Access Compliance Report

Public Rights-of-Way

(Curb Ramps)

Intersection ID: 14843	Main Street: LYNDHURST_AV	Cross Street: MEACHAM_ST	Location: S
ADA ID: 613579B79B24	Ramp Type: BlendTrans1	Initial Pass/Fail: Fail	Overall Compliance: No
Severity Score: 8.75			
Codes/Mitigation Info/Possible Solution		Field Measurements/Component Compliance

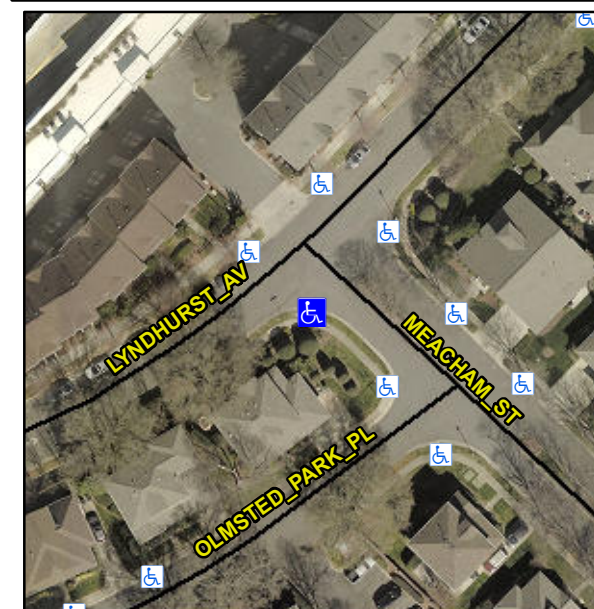
Not Found, R304.5.1

Compliance	Description	Data	Compliance	Description	Data
N/A	Ramp Length (in)	50.0	Yes	BlendTrans Slope (%)	2.3
No	Ramp Width (in)	43.0	Yes	BlendTrans XSlope (%)	1.5
N/A	Flare Type LT	N/A	N/A	Flare Type RT	N/A
N/A	Flare Slope LT (%)	N/A	N/A	Flare Slope RT (%)	N/A
N/A	Flare Traversable LT?	N/A	N/A	Flare Traversable RT?	N/A
N/A	Landing Length (in)	N/A	N/A	DWS Provided?	N/A
N/A	Landing Width (in)	N/A	N/A	DWS Contrast?	N/A
N/A	Landing Slope (%)	N/A	N/A	DWS Length (in)	N/A
N/A	Landing X Slope (%)	N/A	N/A	DWS Full Width?	N/A
N/A	Landing Curb? (Y/N)	N/A	N/A	DWS Offset (in)	N/A
N/A	Shared Landing?	N/A			
N/A	Gutter Ponding?	N/A	N/A	Gutter Slope (%)	N/A
N/A	Gutter Lip Ht (in)	N/A	N/A	Gutter X Slope (%)	N/A
N/A	Painted X Walk1?	No	N/A	Painted X Walk2?	No
	X Walk 1 Direction	To NE		X Walk 2 Direction	To NW
	X Walk 1 Width (in)	N/A		X Walk 2 Width (in)	N/A
	X Walk 1 Slope (%)	3.2		X Walk 2 Slope (%)	1.7
	X Walk 1 X Slope (%)	0.9		X Walk 2 X Slope (%)	2.8

N/A	Ramp inside XWalk1?	N/A	N/A	Ramp inside XWalk2?	N/A
	Road Slope (%)	0.8		Clear Space?	N/A
	Road X Slope (%)	2.1	N/A	Clear Space to XWalk (in)	N/A
N/A	Any Obstructions?	N/A	N/A	Storm Grate/Utility Hazard?	N/A
	Obstruction Type			Storm Grate/Utility Type	
		N/A			N/A
			Yes	Surface Condition? (G/P)	Good
			No	Curb Slope (%)	17.9

Remove & Replace Curb Ramp With Two New Directional Ramps or Equivalent.
